Group of Experts on Road Signs and Signals

Report of the Group of Experts on Road Signs and Signals on its fourteenth session

A sign-by-sign assessment by the Group of Experts

A, 20 “INTERSECTION WITH A ROAD TO WHOSE USERS DRIVERS MUST GIVE WAY”

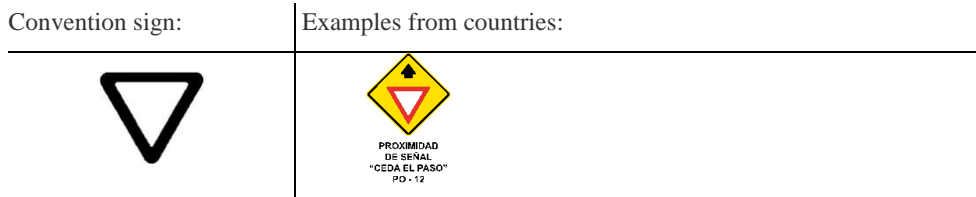
The Group noted that only a very few countries use the sign A, 20 while the majority of countries use the sign B, 1 with additional panel H, 1. This second possibility is introduced with paragraph 6 Article 10 (first sentence). However, the Group noted that both the paragraph 6 as well as point 20 (a) of Section A of Annex 1 require that the same warning is implemented by different signs both being obligatory.

The Group recommended the following amendment to point 20 (a):

A, 27 “INTERSECTION WITH A TRAMWAY LINE”

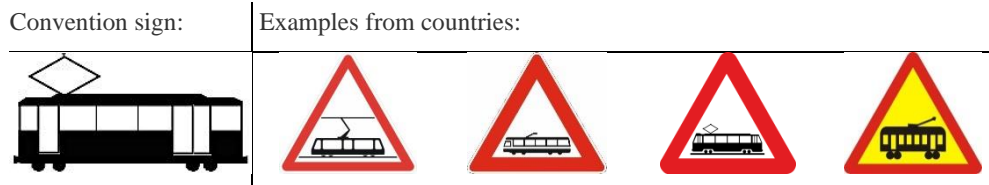
The Group believes that an essential feature of the tramway symbol is the presence of a pantograph. It should be of a diamond shape which is not the case for Albania, Denmark, France, Italy, Republic of Moldova and Vietnam. Some countries place the pantograph in the middle which the Group considers to be in conformity with the Convention. Also, the symbol should not include the tramway tracks (as it is the case for Belgium, Croatia, France, Finland, Montenegro, Norway, Poland, Slovakia and Switzerland) to ensure that the tramway symbol is understood by itself.

A, 28 a, A, 28 b, A, 28 c “SIGNS TO BE PLACED IN THE IMMEDIATE VICINITY OF LEVEL-CROSSINGS”

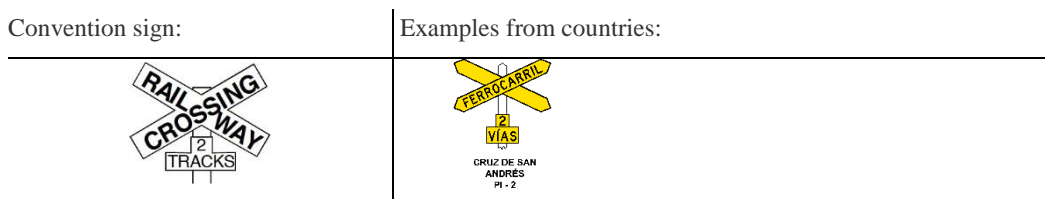
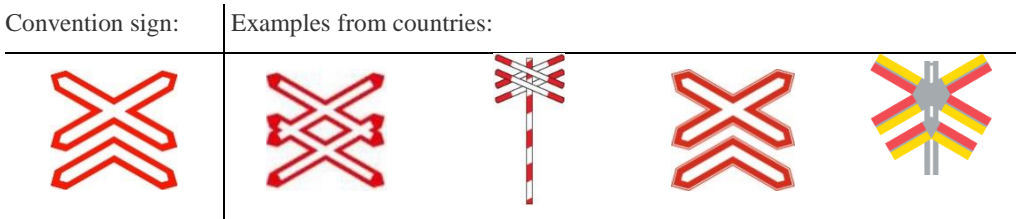
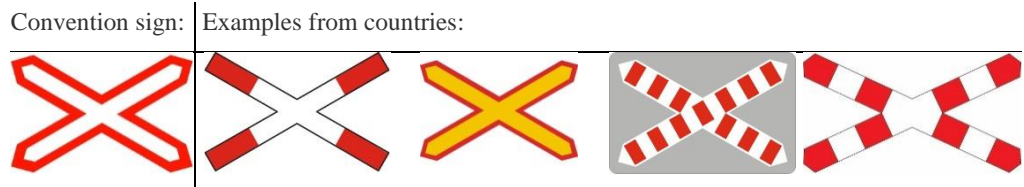
The Group recommended to pair the signs A, 28 a and A, 28 c (with no additional panel) to indicate the immediate vicinity of railway line with one track and to pair the signs A, 28 b and A, 28 c (with additional panel) to indicate the immediate vicinity of railway line with at least two tracks.

The Group recommended to amend the text of point 28 (a) and (b), section A, Annex I as follows:

- (a) There are ~~three~~ **four** models of sign A, 28 referred to in Article 35, paragraph 2 of this Convention: A, 28 a, A, 28 b, ~~and~~ A, 28 c **and A, 28 d**.
- (b) Models A, 28 a and A, 28 ~~b~~ **c** shall have a white or yellow ground and a red or black border **or may show red stripes (with or without a red or black border) on condition that neither the general appearance nor the effectiveness of the signs is impaired thereby**; model A, 28 ~~e~~ **b and A, 28 d** shall have a white or yellow ground and a black border; the inscription on model A, 28 ~~e~~ **b and A, 28 d** shall be in black letters. Models A, 28 ~~e~~ **b and A, 28 d** shall be used only if the railway line comprises at least two tracks; with model A, 28 ~~e~~ **d** the additional panel shall be affixed to indicate the number of tracks.

B, 3 "PRIORITY ROAD"

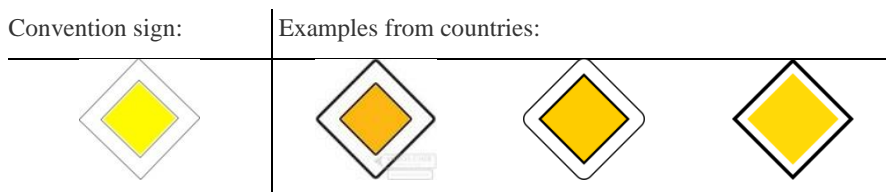
The Group noted that some countries do not use the black narrow strip for the yellow square in the centre, and recommended that they do so.

It then suggested to insert the following changes to Annex 1, Section B, Point 3:

B, 4 "END OF PRIORITY"

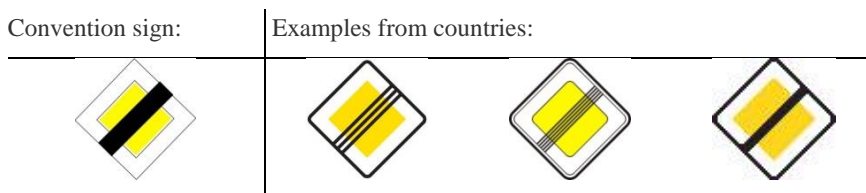
The Group noted that some countries do not use the black narrow strip for the yellow square in the centre, and recommended that they do so.

The Group recommended to amend the definition of sign B, 4 as follows:

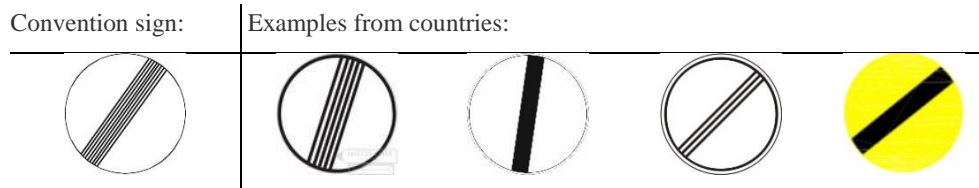
Two countries (Czech Republic and Slovakia) use a thin horizontal line instead of a black horizontal bar. The Group considered it not to be in conformity with the Convention.

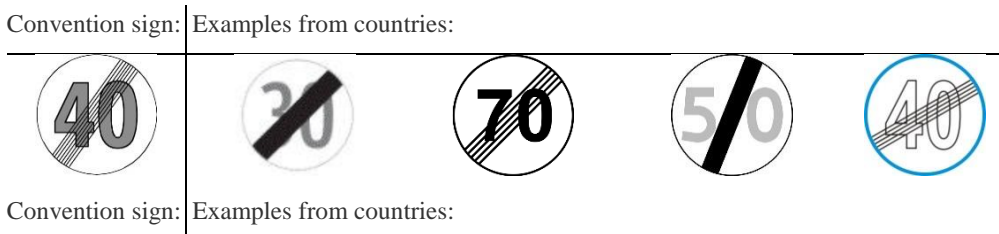
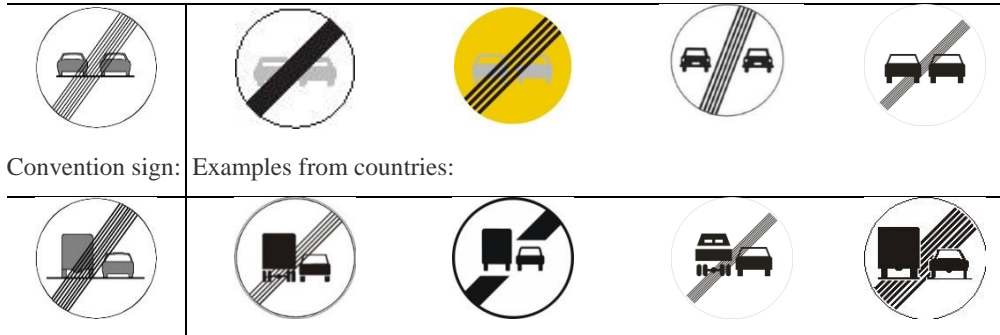
The Group noted many visual differences in the type of digits used by Contracting Parties, and recommended that all the digits/symbols should be light grey and not solid black or white. The Group recommended that the oblique bar consisting of parallel lines strikes through both digits. The solid bar can be interrupted over the digit.

The Group noted that one country (Vietnam) introduces a blue rim on the sign C, 17 b, which is not considered to be in conformity with the Convention.

The Group proposed to amend the Convention, Annex 1, Section C, point 8 (b) as follows: The point at which a particular prohibition or restriction notified to moving vehicles by a prohibitory or restrictive sign ceases to apply shall be indicated by sign C, 17 b "END OF SPEED LIMIT" or sign C, 17 c "END OF PROHIBITION OF OVERTAKING", or sign C, 17 d "END OF PROHIBITION OF OVERTAKING FOR GOODS VEHICLES". These signs shall be similar to sign C, 17 a, but shall show, in addition, in light grey the symbol of the prohibition or restriction which has ceased. **The diagonal oblique band can may be interrupted when crossing the grey symbol. If not interrupted, the diagonal band shall be placed over the grey symbol.**

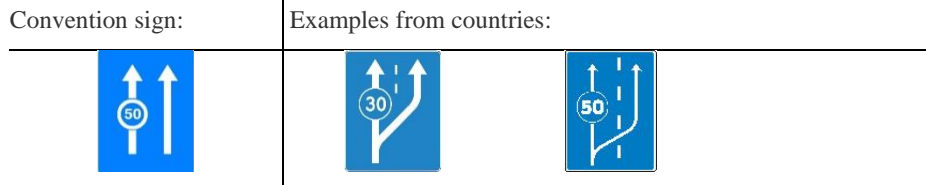
Many countries use road markings (broken line) on this sign. The Group recommended the symbols on this sign not to include road markings ie., broken lines as the arrows indicate the “lanes”.

The Group recommended that for the E, 1 b sign the sign D, 7 is used with a white rim.

E, 1 c “SPEED LIMITS APPLYING TO DIFFERENT LANES”

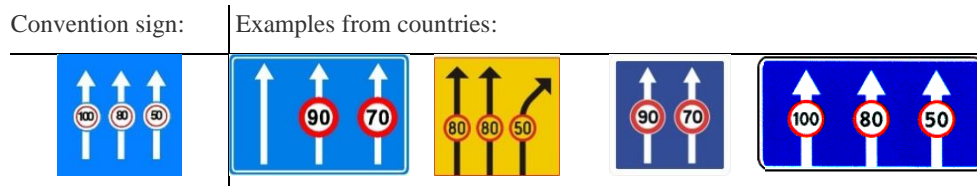
Azerbaijan used a wrong example for E, 1 c sign (truck entry prohibition sign instead of speed limit sign).

The Group recommended that the E, 1 c sign is improved by placing the sign C, 14 on the arrows and adding a white rim.

E, 2 a “SIGNS INDICATING LANES RESERVED FOR BUSES”

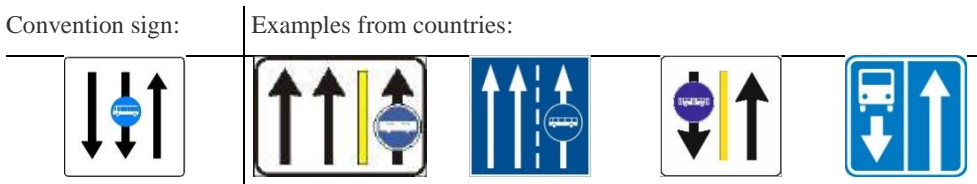
Several countries (Azerbaijan, Belgium, Croatia, Latvia, Luxembourg, Montenegro and Ukraine) use examples for E, 2 a that do not correspond to the examples of the Convention.

Many countries use road markings (broken or continuous line) on this sign. The Group recommended the symbols on this sign not to include road markings as the arrows indicate the “lanes”.

E, 2 b “SIGNS INDICATING LANES RESERVED FOR BUSES”

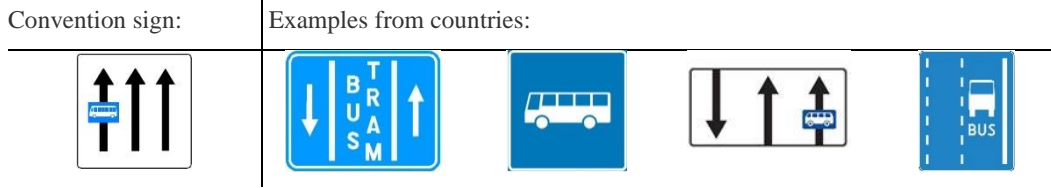
Several countries (Belgium, Croatia, Finland, Latvia, Montenegro, Poland and Ukraine) use examples for E, 2 b that do not correspond to the examples of the Convention.

Many countries use road markings (broken or continuous line) on this sign. The Group recommended the symbols on this sign not to include road markings as the arrows indicate the “lanes”.

E, 3 a “ONE WAY”

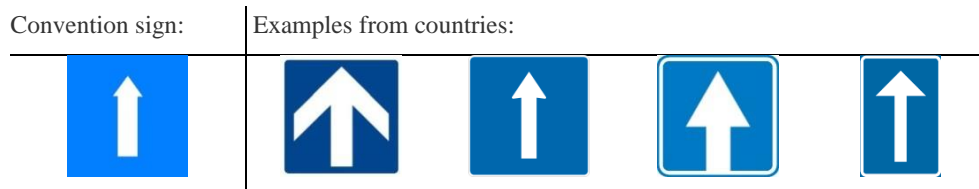
There are minor differences in shape of arrow heads, arrow tails, proportions of arrows within the sign. The Group recommended Contracting Parties to pay closer attention to the design details, in particular, to the shape of the arrow head (by making it wider to improve the legibility). The tail of the arrow should not touch the edge of the sign.

Some countries (e.g. Sweden) use rectangular shape for this sign.

The Group recommended that the symbol in the Convention be modified by enlarging the arrow head.

F, 16 “BEACH OR SWIMMING POOL”

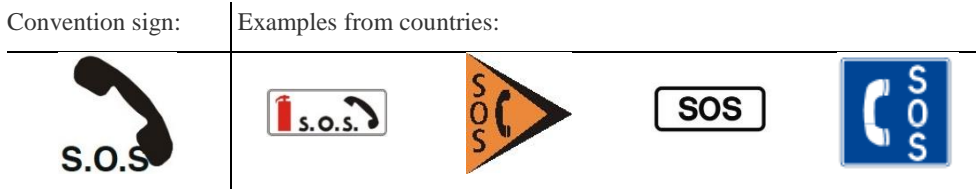
The Group recommended that the sign be removed from the European Agreement.

G, 2a and G, 2b “NO THROUGH ROAD” (advance direction signs)

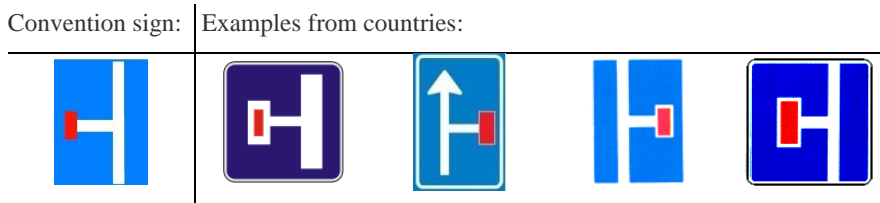
The Group noted that Belgium inserted sign G, 13 into RSMS for both signs, and Latvia inserted G, 13 for G, 2a.

The Group also noted that the G, 2a Slovakian sign had a white border, instead of a rim, around the red bar. The Group further noted that the G, 2a sign from the Netherlands contained an arrow. The Group considered these signs not to be in conformity with the Convention.

The Group noted that, in the G, 2a signs of some countries (Azerbaijan, Greece, Lithuania, Republic of Moldova, Russian Federation, Ukraine, Uzbekistan and Viet Nam), and in the G, 2b sign of Greece, there was no visible space between the symbol and the edge of the sign. The Group believed that this was not a good practice for sign legibility.

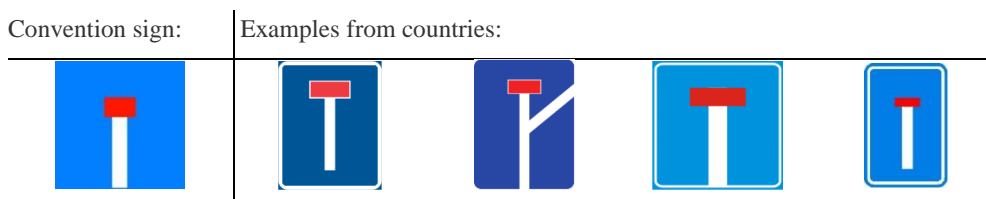
The Group of Experts noted that a few countries had inserted variants of the G, 13 sign or the incorrect sign into the RSMS. It was of the view that the correct signs should replace the incorrect signs.

The Group also noted that a number of countries did not have the white part of the symbol going to the bottom edge of the sign.

The Group also noted that a white narrow strip around the red bar was mandatory for Contracting Parties to the 1971 European Agreement. In this regard, a few countries were not in conformity.

The Group was of the view that with regards to the Convention sign, there was insufficient space between the symbol and the bottom edge of the sign. The Group believed that this was not a good practice for sign legibility. It recommended that a white narrow strip be placed around the red bar.

The Group recommended the following amendment to the provision for the G, 13 sign:
